CHRIS TEAM SUBDIVISION

FINAL DRAINAGE REPORT

EL PASO COUNTY PROJECT NO: SF246

CHRIS TEAM SUBDIVISION PROPOSED CONDITIONS DRAINAGE MAP

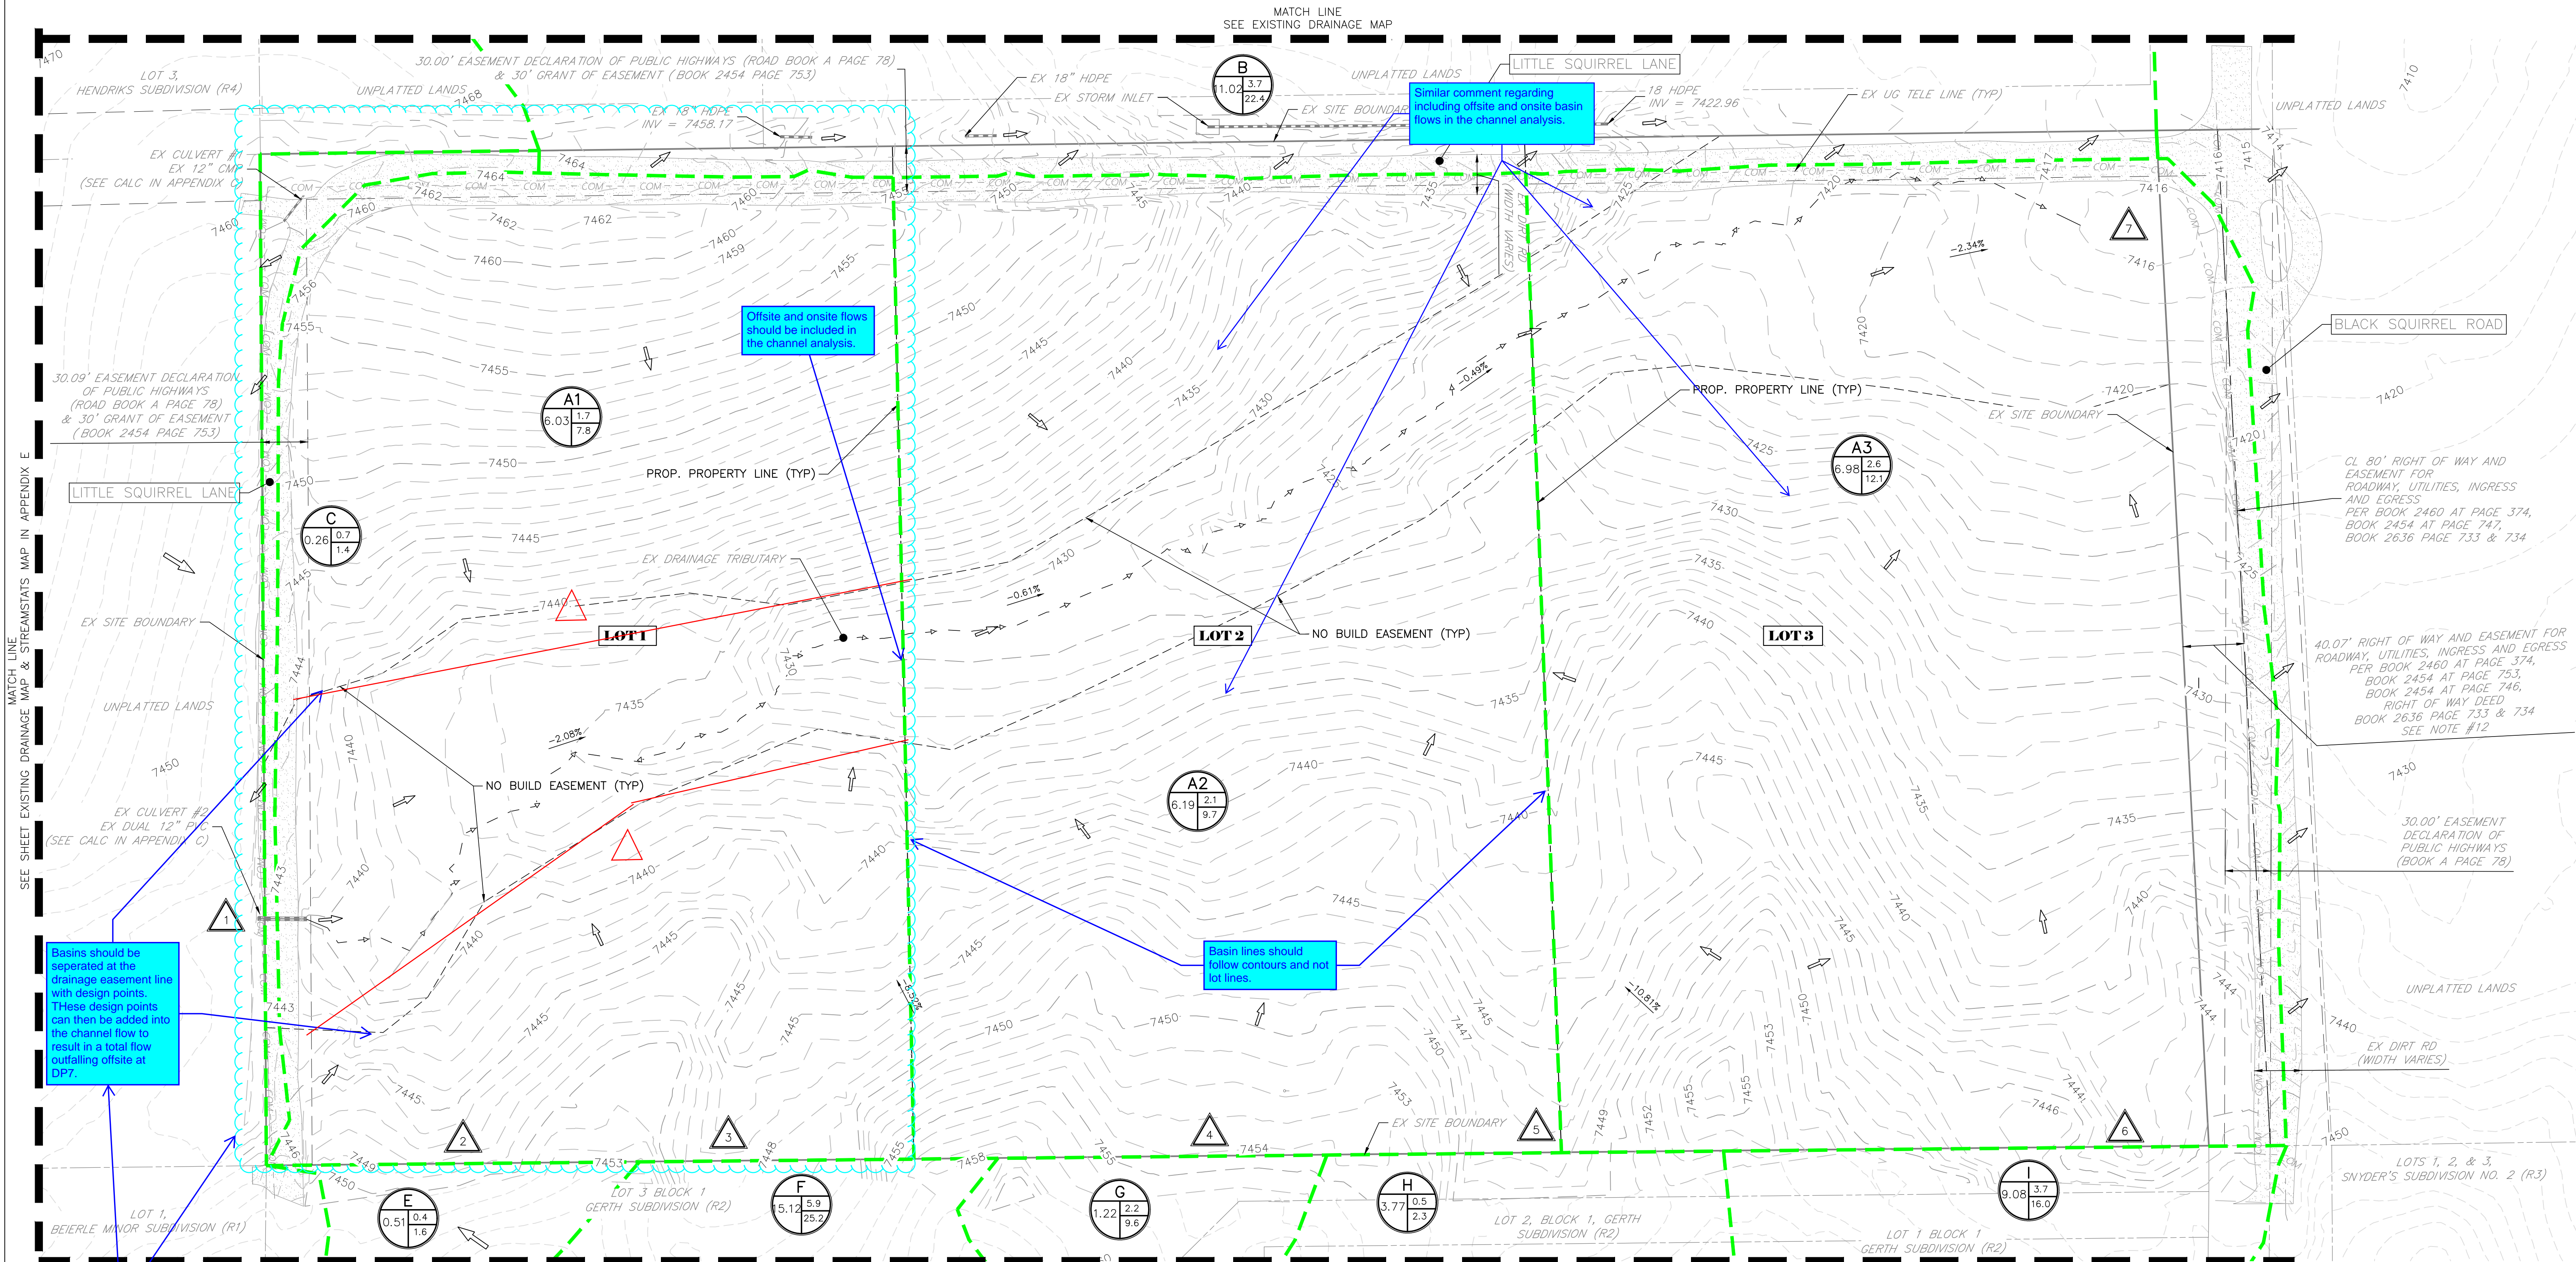
This is to show an example of what this note is asking for. These basin lines may be shown in different places based on other comments.

CHANNEL CROSS SECTION MAP

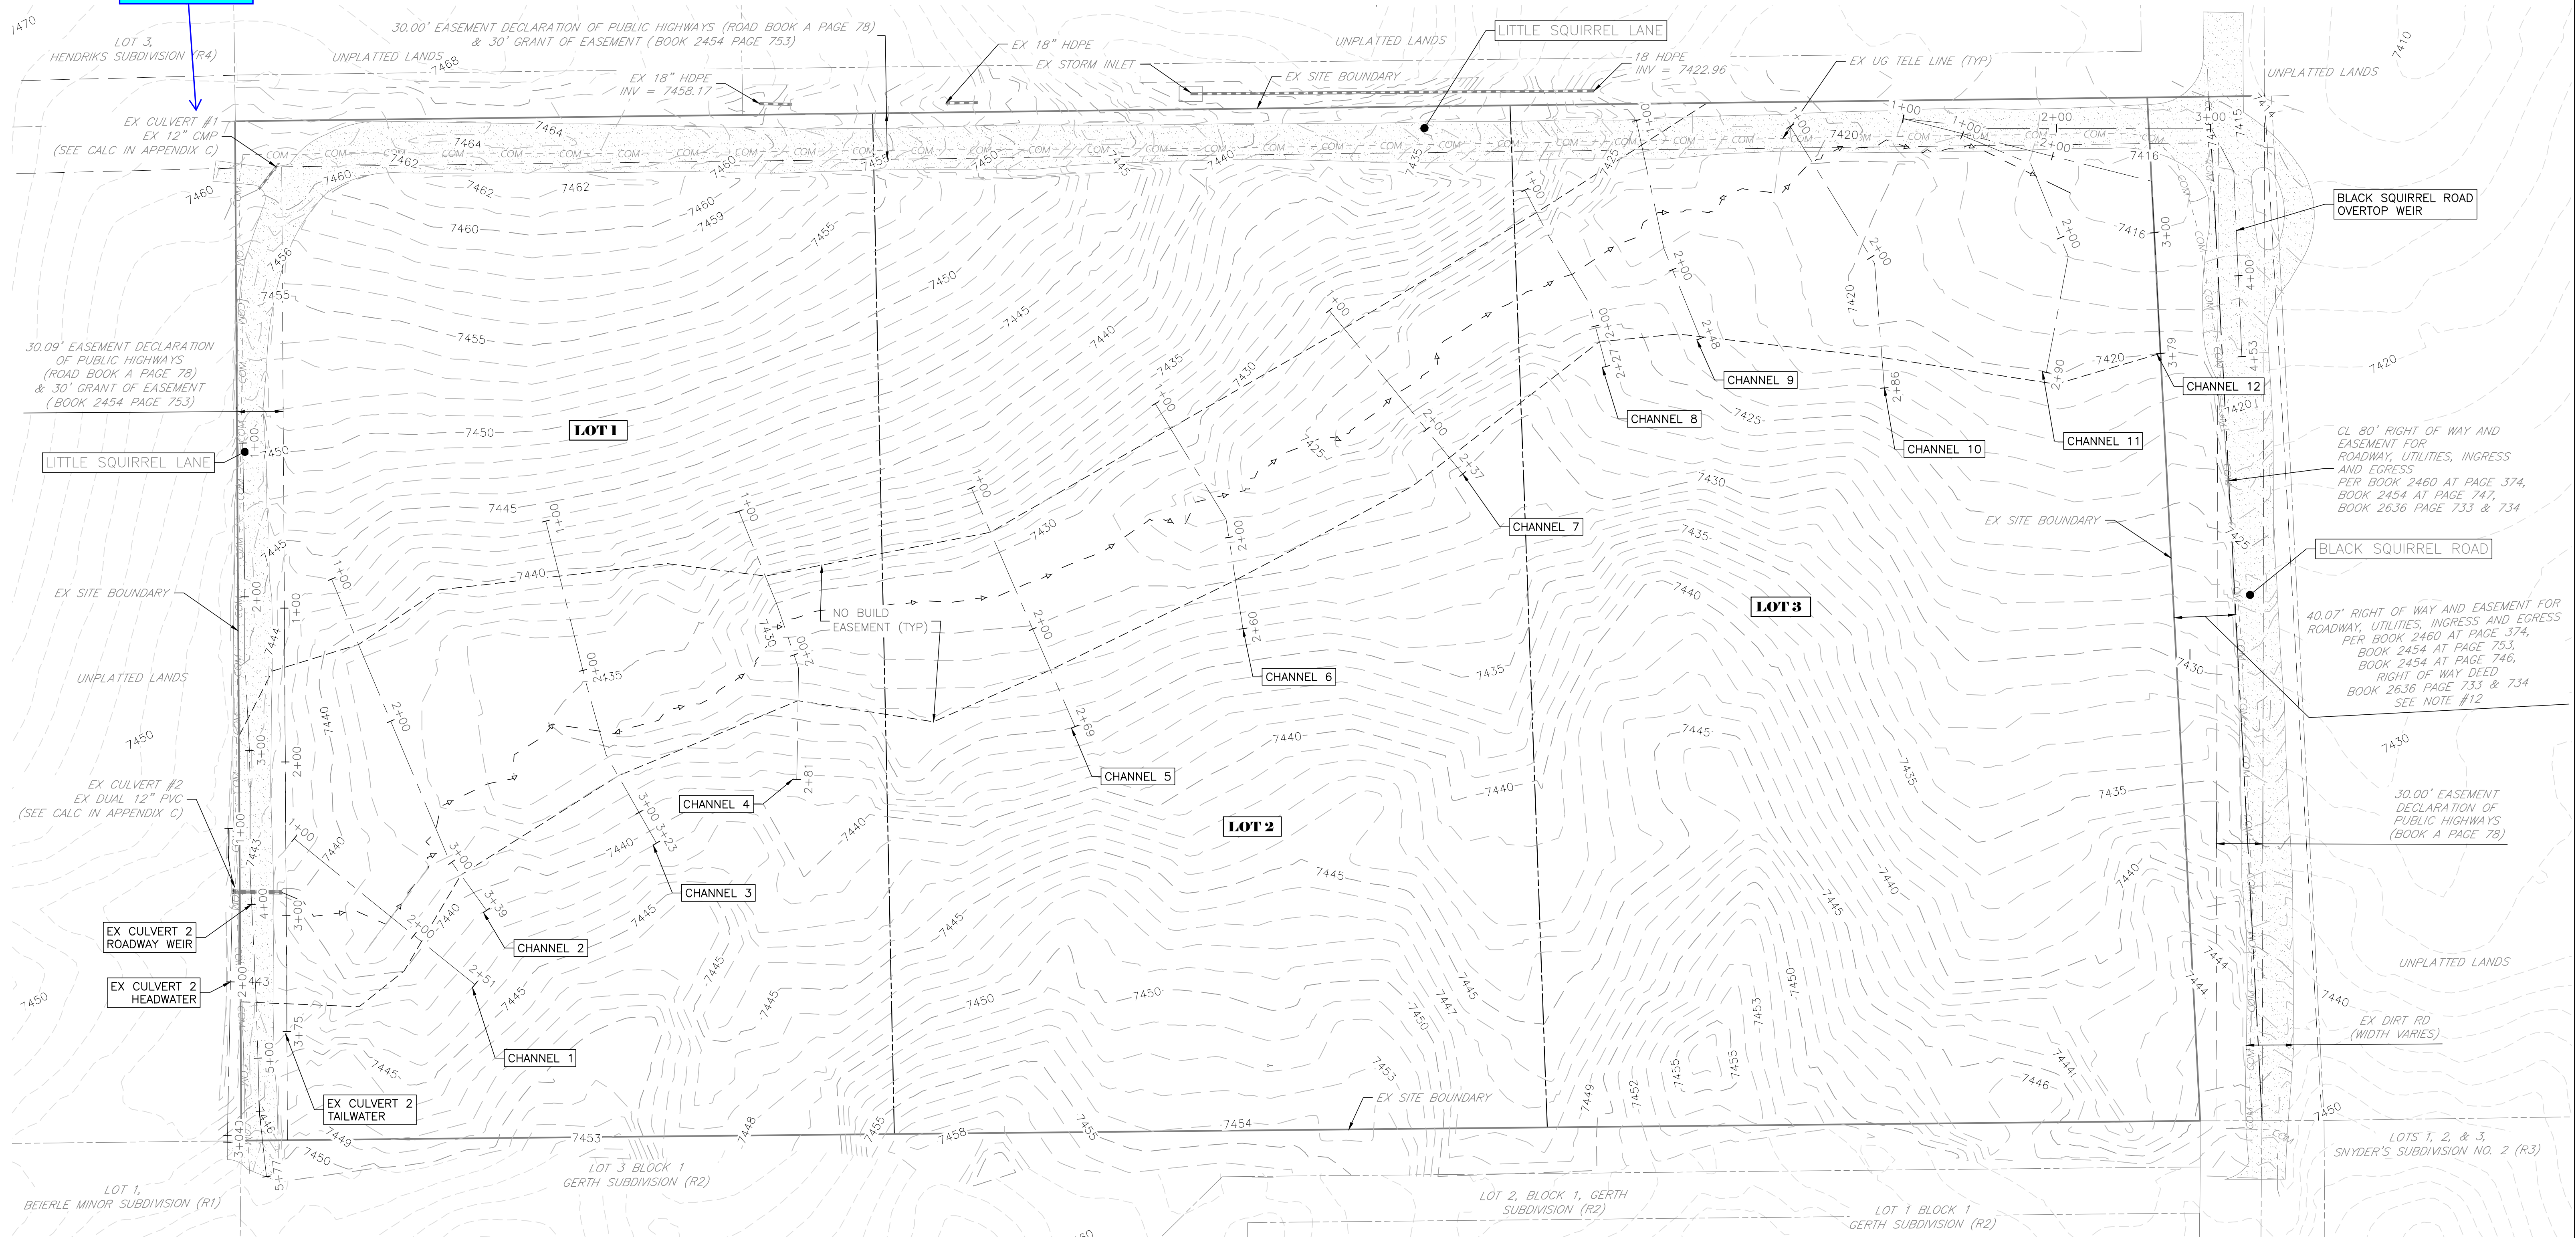
Please identify this culvert with a clearer label for this culvert as was done for the other culverts analyzed.
